ADDENDUM 01

Project Title: **Blinn Mechanical Project – Brenham – Melcher + BCPA Phase 2**
RSE Project #: **1540**

This **ADDENDUM** shall modify, amend, extend and become a part of the Contract Documents dated 1/13/25 prepared by Ramirez Simon Engineering, LLC (RSE) in accordance with the terms therein, as if written out in full therein and bound originally therewith.

4 ELECTRICAL BCPA2 OVERALL DEMO FLOOR PLAN
1" = 30'-0"

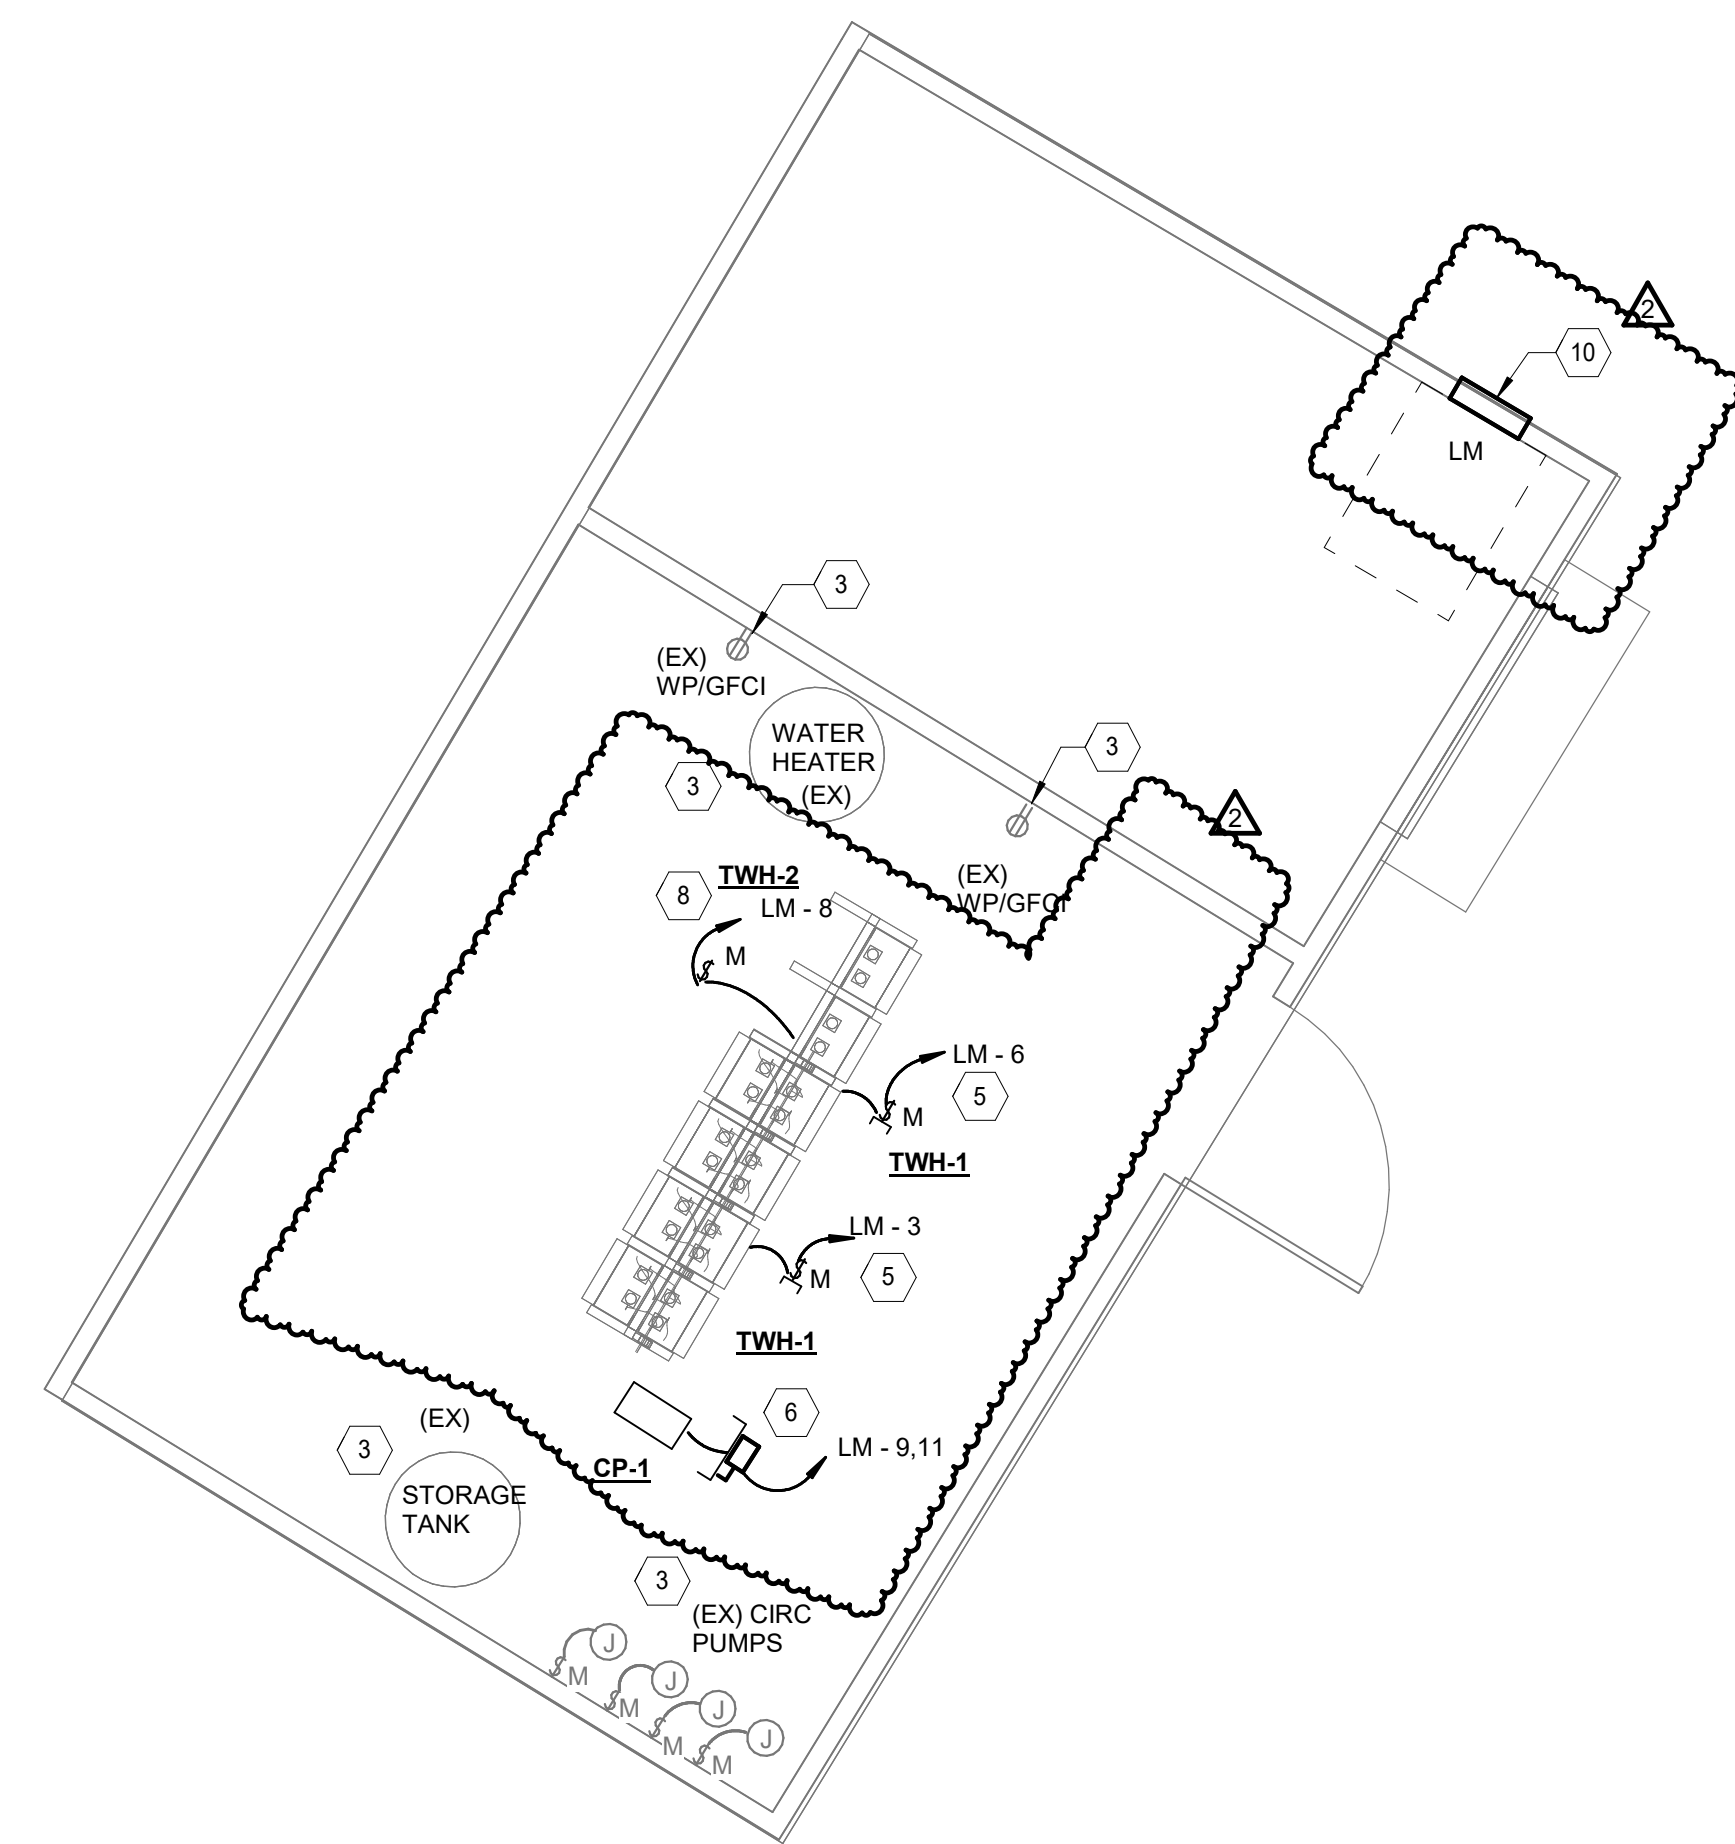
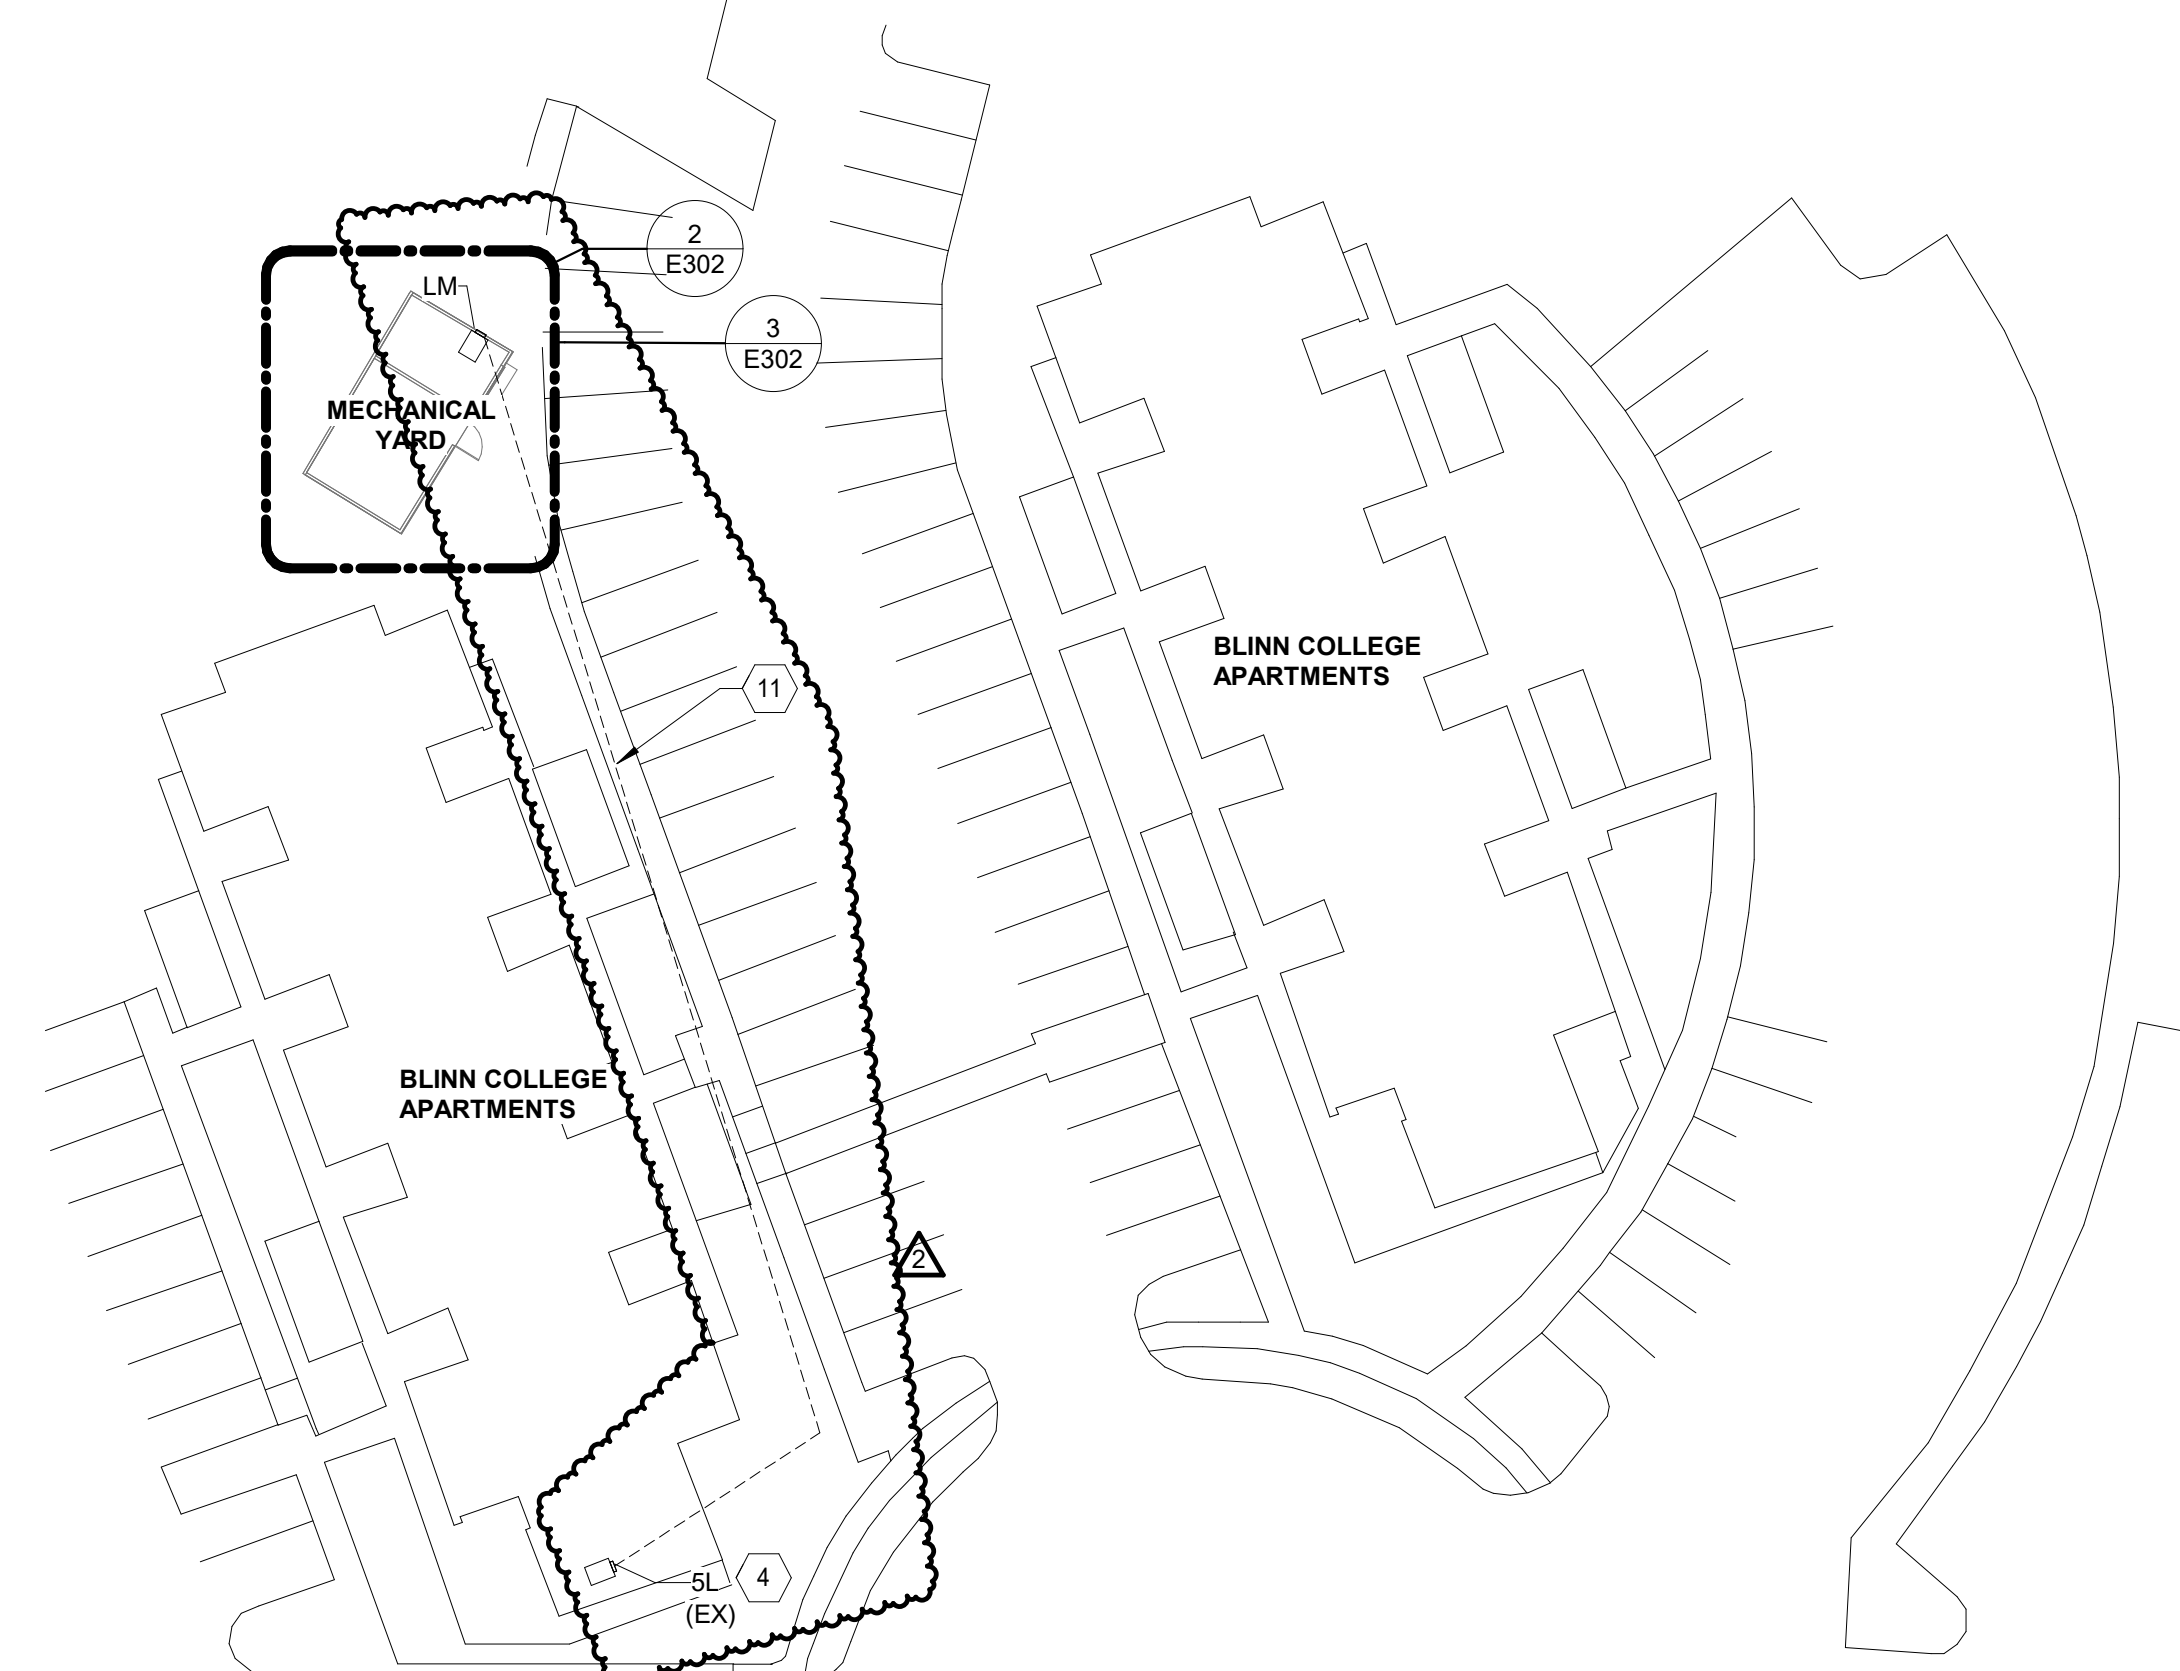
2. E302-ELECTRICAL BCPA2 FLOORPLAN
 - a. Added scope to replace panel LM under Alternate #1. This includes replacing the existing feeder served from panel 5L.
 - b. Added demo floor plan to demolish the existing feeder for panel LM under Alternate #1.
 - c. Added routing for new feeder to serve panel LM under Alternate #1 to the overall floor plan.
 - d. Qty of tankless heaters has changed from 14 to 8. Tags for tankless heaters was changed from BI-1 and BI-2 to TWH-1.
 - e. Added power for additional tankless heaters TWH-2 under Alternate #1.
 - f. Circulation pump CP-2 has been removed.

- g. Updated circuiting for CP-1.
 - h. Removed power for heat tracing control panel HTCP-1.

E501

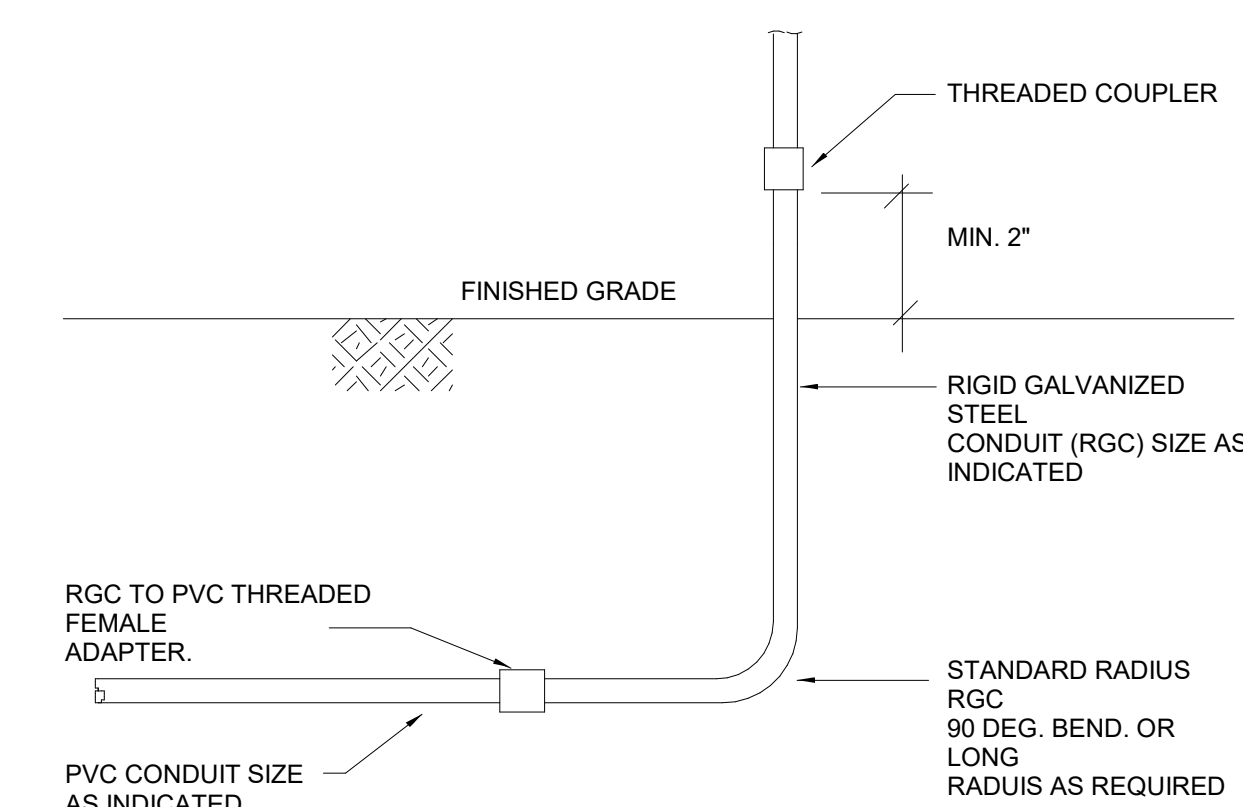
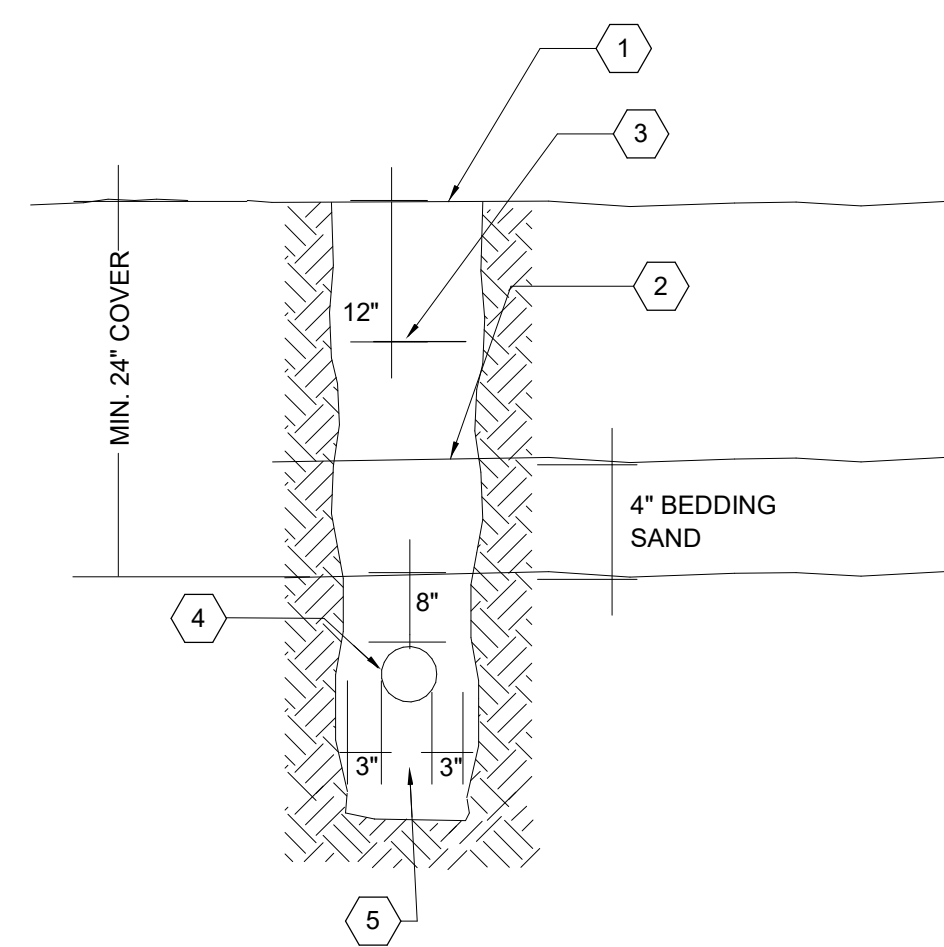
- 3. E501-ELECTRICAL DETAILS
 - a. Added details for conduit stub-ups, pullbox mounting and feeder ductbank.
